## "OOPS, WE GOOFED"

### Volume 5 page 48:

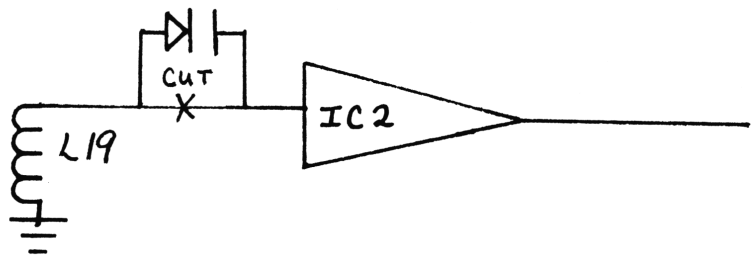
M.A.R.S. is no longer available.
